REVISED AGENDA
The City of Beaufort
HISTORIC DISTRICT REVIEW BOARD

Wednesday, April 14, 2021, 2:00 P.M.

Historic Review Board Meeting Staff Report

1214 Duke Street, Alteration

A First Floor Plan
SD101 SCALE: 3/16" = 1'-0"

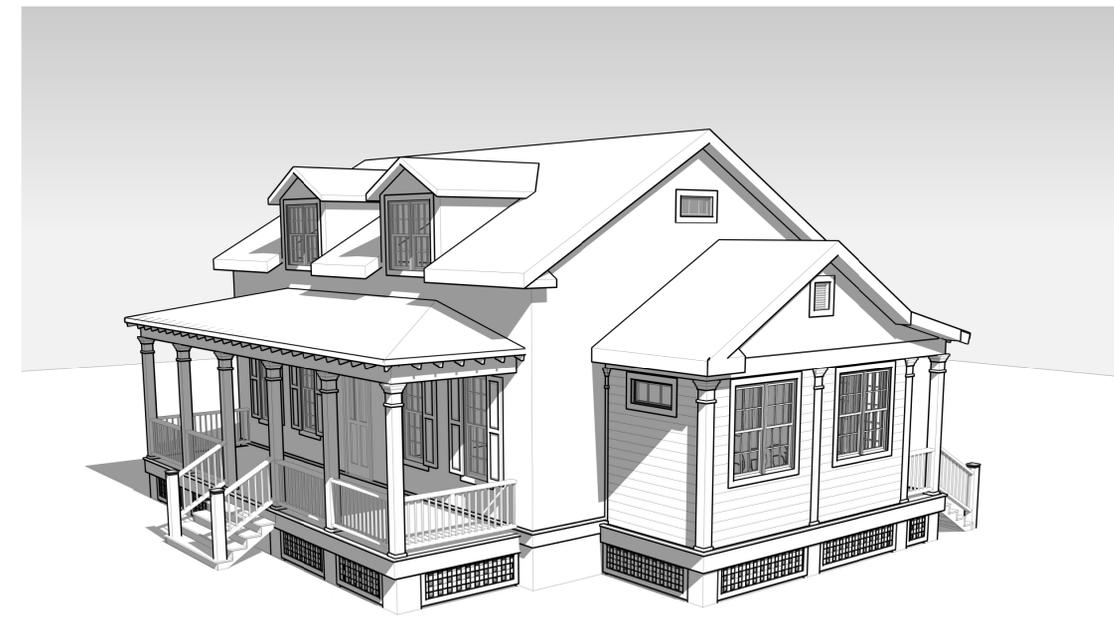
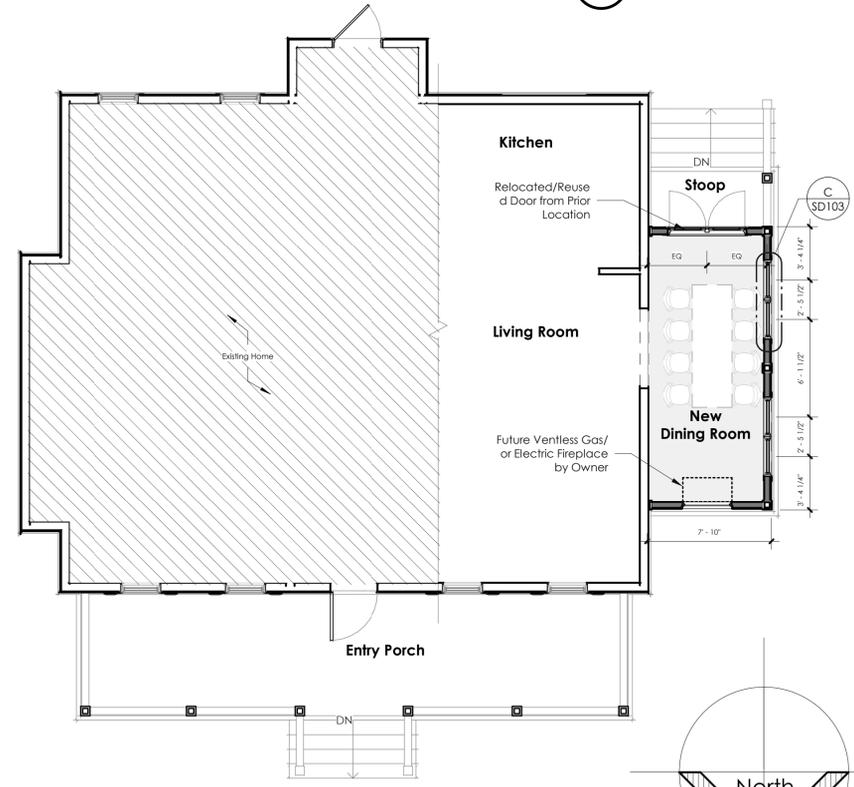
1. The proposed porch enclosure is not compliant with the intent of the Beaufort Preservation Manual Supplement and the Northwest Quadrant Design Guidelines. The walls of the enclosure must be installed behind the existing porch columns and balustrade per the referenced standards above, and the relationship of solid and void should better match that which exists on the current screened in porch. All infill related to a porch enclosure should be positioned such that it recedes back from faces of columns and beams so that the original porch is always visibly apparent.

2. Staff recommends altering the design to maintain the existing balustrade and build the infill walls behind it and the columns as illustrated on page 33 of the Preservation Manual Supplement.

3. Staff recommends making the infill wall as transparent as possible, with vertical mullions introduced minimally, only to set proper window proportions. Staff recommends placing one horizontal framing member at balustrade height, as recommended by the Beaufort Preservation Manual Supplement, to separate the upper transparent portion from the lower transparent portion.

C Detail @ New Jambs & Muller Windows
SD103 SCALE: 3/8" = 1'-0"

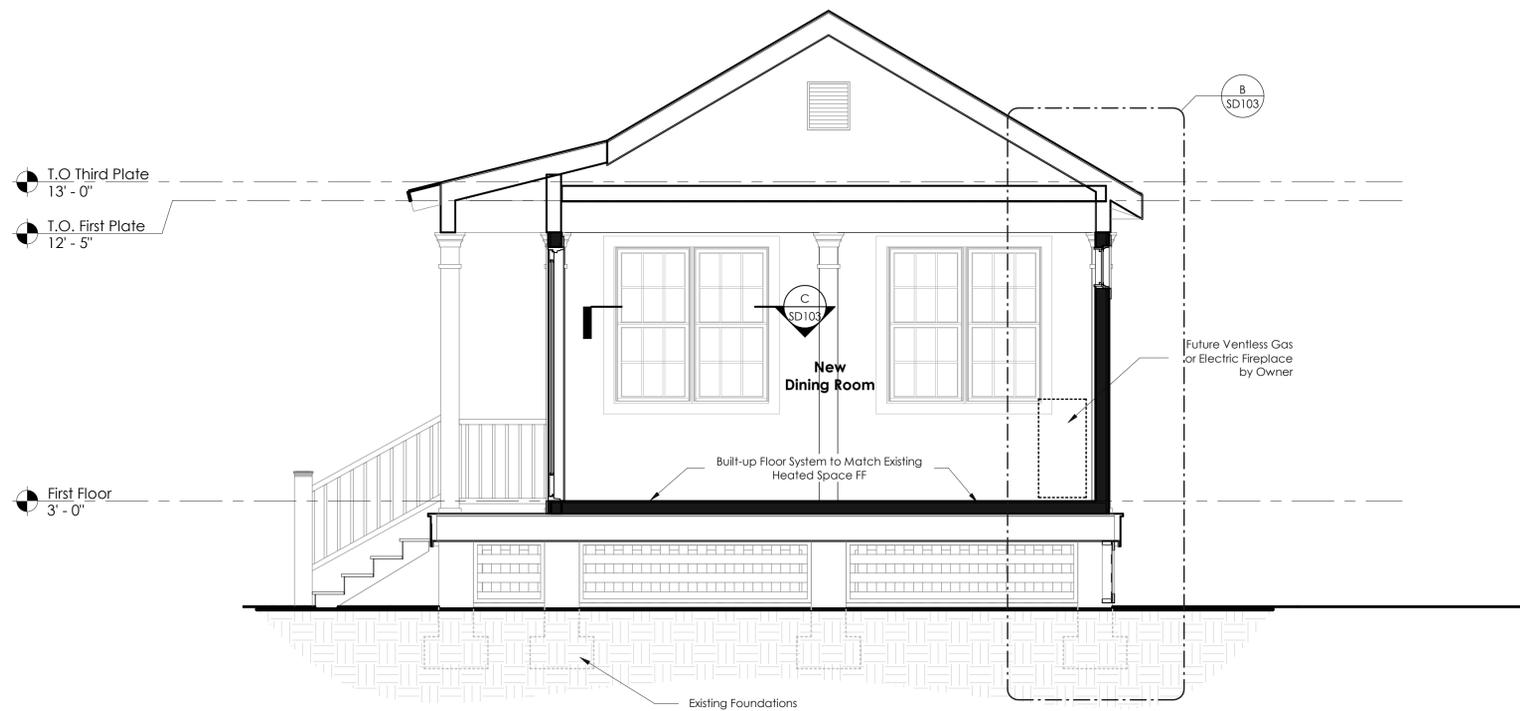
4. Detail C on Sheet SD103 (Detail at New Jambs and Mullled Windows) shows that the edge of the plywood sheathing will be visible between the exterior window trim and the window jamb. Applicant to ensure that the windows are detailed to obscure the sheathing from view and protect it from water intrusion that will cause deterioration over time.
